Simple Stepper Motor Analyzer Mk2

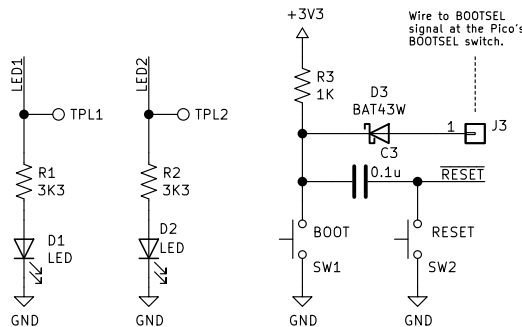
DNP. FOR DEV ONLY

Schottky diode D3 should have VForward <= 650mv and low capacitance to reduce BOOTSEL noise on the RESET line.
